DESIGN REVIEW BOARD MEETING AGENDA

- A. **DRB 03-10 – Town of Moraga (Applicant and Owner) Corporation Yard at 331 Rheem Blvd:** An application for revisions to the landscaping across the frontage of 331 Rheem Boulevard in accordance with the requirements of the conditional use permit for the relocation of the Town of Moraga Corporation Yard. APN 255-020-003.

On January 4, 2010 the Planning Commission approved a use permit for the relocation of the Town's corporation yard from the Hacienda de Las Flores Park to 331 Rheem Boulevard. The conditions of approval are listed in Planning Commission Resolution Number 02-2010, which is attached as **EXHIBIT B**. Condition number 2 states: "*Prior to occupancy of the property a plan shall be presented to the Design Review Board for review and approval for visual screening of the storage yard from the scenic corridor*". Condition number 4 states: "*In order to reduce the use of water in accordance with EBMUD guidelines, serious consideration shall be given to replacement of the turf areas at the front of the building with drought tolerant ground cover, shrubs and trees conforming to the Town's Design Guidelines for scenic corridor landscapi

EXHIBIT A

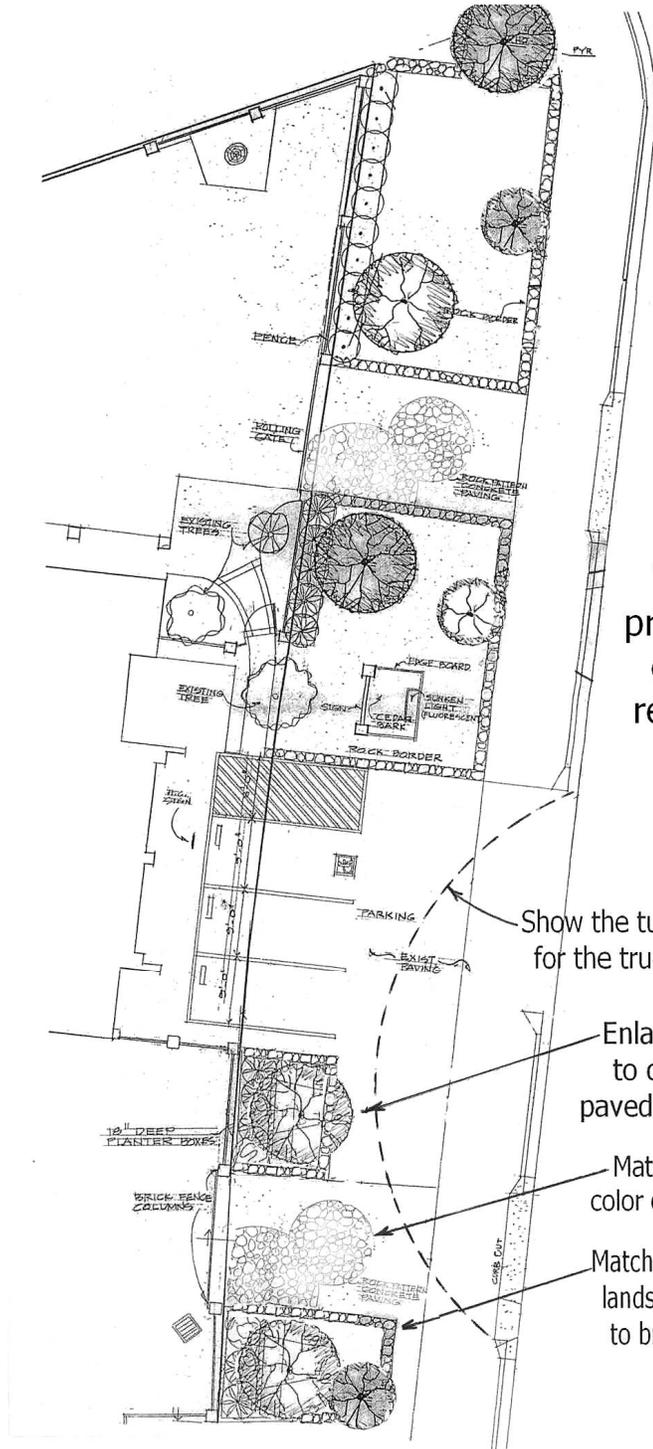
Three street trees
 previously in sidewalk
 cutouts are shown
 relocated to planting
 areas adjacent to
 the sidewalk

Show the turning radius arc
 for the truck loading area

Enlarge western planters
 to compensate for new
 paved driveway at east side.

**LANDSCAPE PLANS AND
PLANT DESCRIPTIONS FOR
CORPORATION YARD**

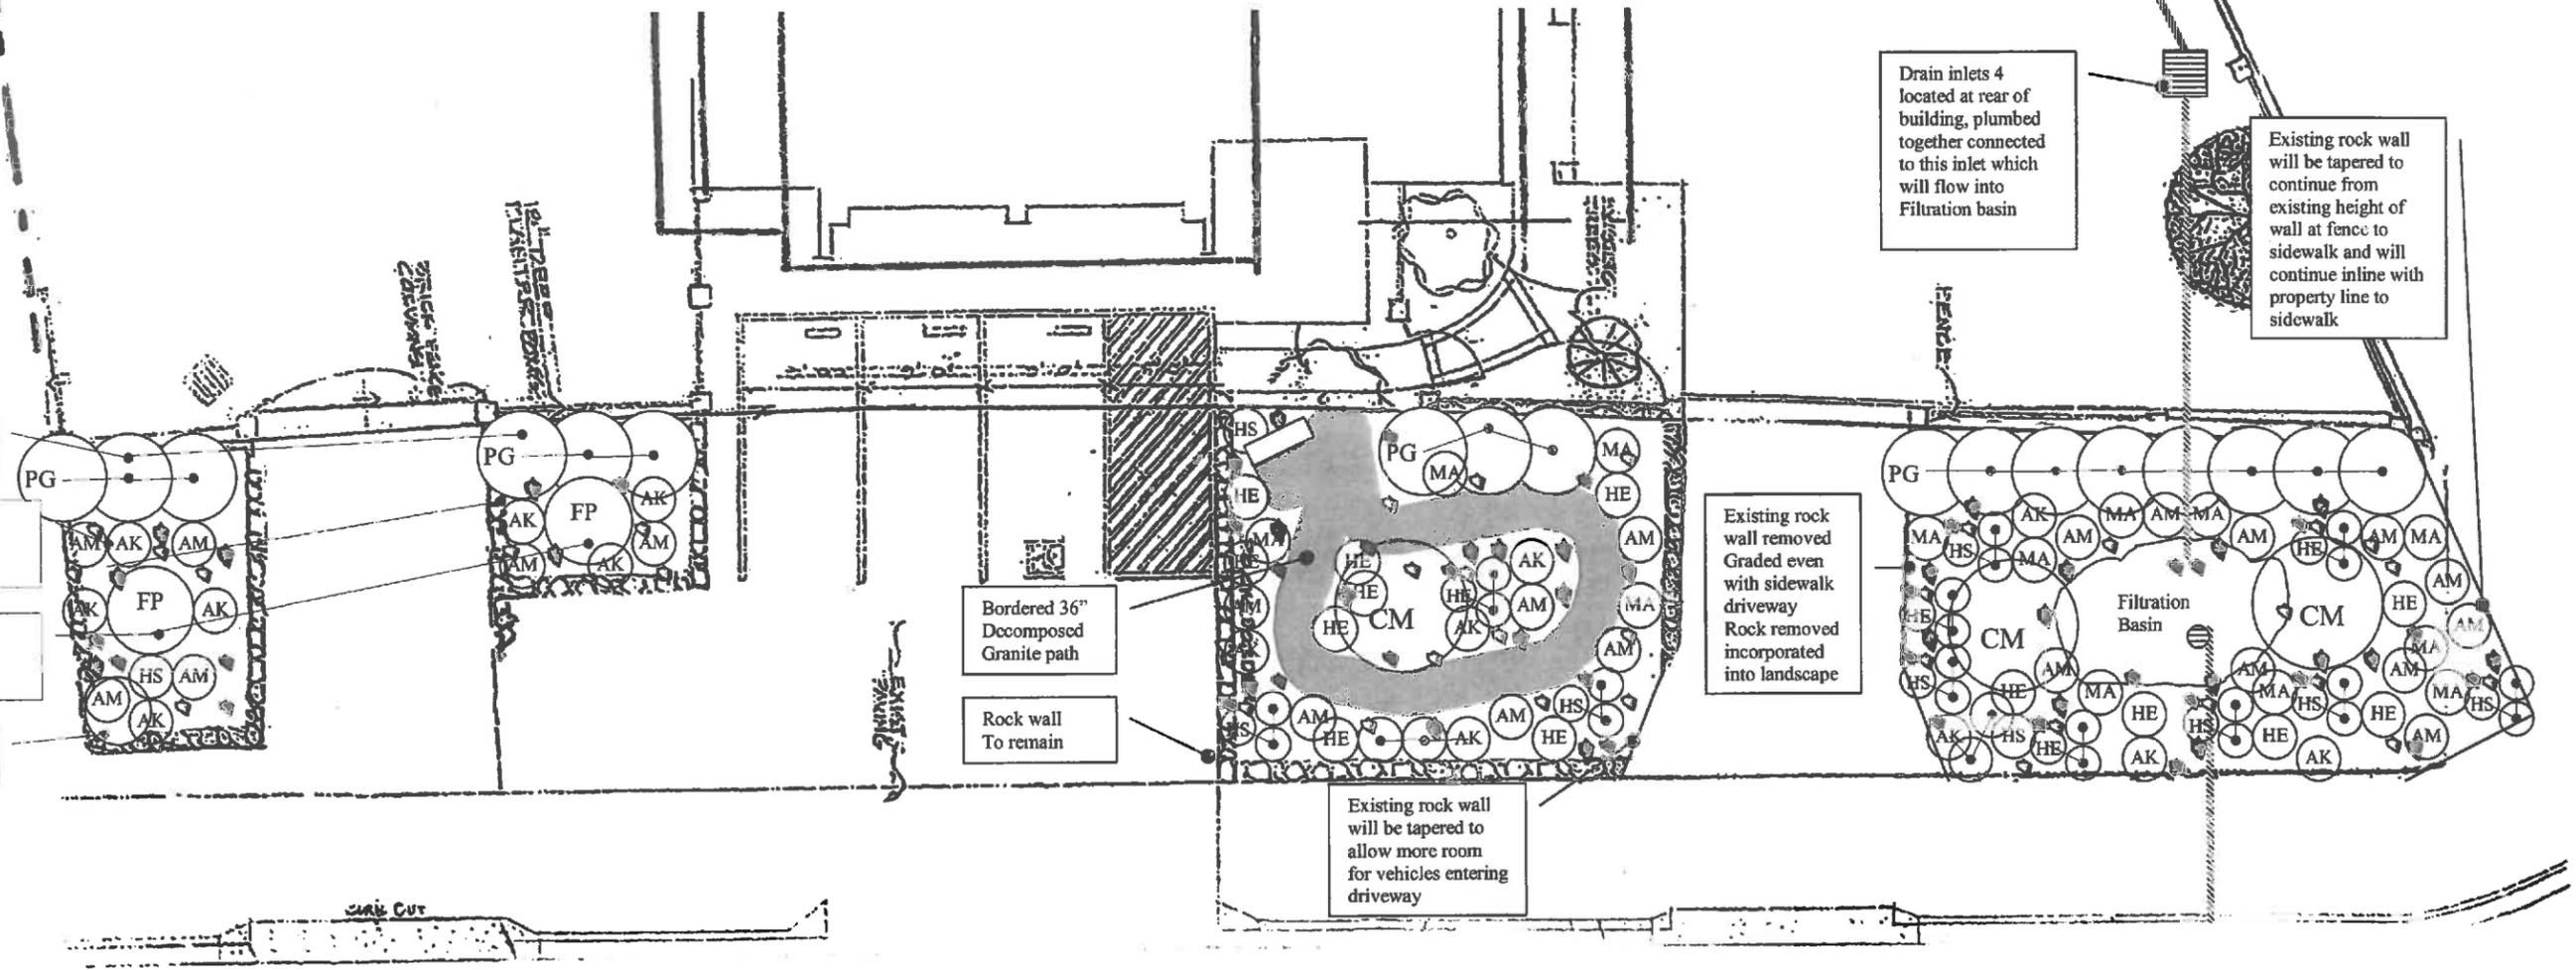
- L1.3, L3.13, L3.14 and L3.15 The existing irrigation system should be modified after the existing lawn areas are removed, with a drip irrigation system for the drought tolerant plants and the electronic controller for the irrigation system should be replaced with one that has an automatic rain shut-off feature.

- L3.3 Larger canopy type trees, such as Chinese Pistache or Oak trees, could be considered for the planting islands at either side of the three public parking spaces at the front of the building to provide some shade for the vehicles.

- L3.8 The impact of the new planting could be enhanced if there were more clusters of the same species grouped together in a natural way rather than alternating different species as presented on the plan. The arrangement of the rocks could also be improved by grouping some of the rocks together.

- L3.9 The Board might consider granting an exception to the requirement to have 25% of the proposed trees planted with 24" box size trees. However, if 15-gallon trees are used then it is suggested that the conditions of approval require excavation of planting holes that are 3-times the root ball size with added soil amendments to help accelerate the growth of the trees. If 24" box specimens are used, then they need to be carefully selected to make sure they are not root bound.

2. In lieu of planting 24" box specimen trees for a minimum of 25% of the trees as required by Design Guideline L3.9, the specifications for planting the 15-gallon trees shall require excavation of planting holes that are 3-times the root ball size with backfill to include a significant amount of added soil amendments to help accelerate the growth of the trees. If any 24" box specimen trees are used, the specifications on the plan shall require that the trees are carefully selected to make sure they are not root bound and have not been in the container for an excessive amount of time.

3. In accordance with Design Guidelines L1.3, L3.13, L3.14 and L3.15, the existing irrigation system shall be modified after the turf areas are removed and a drip irrigation system shall be installed for the drought tolerant plants. The electronic controller for the irrigation system shall be replaced if necessary with one that has an automatic rain shut-off feature.

4. Consider making the following changes to the landscape plans:
 - a. in compliance with Design Guideline L3.3, consider planting a canopy type tree, such as Chinese Pistache or an Oak tree species, in the planting islands at either side of the three public parking spaces at the front of the building to provide shade for the vehicles.
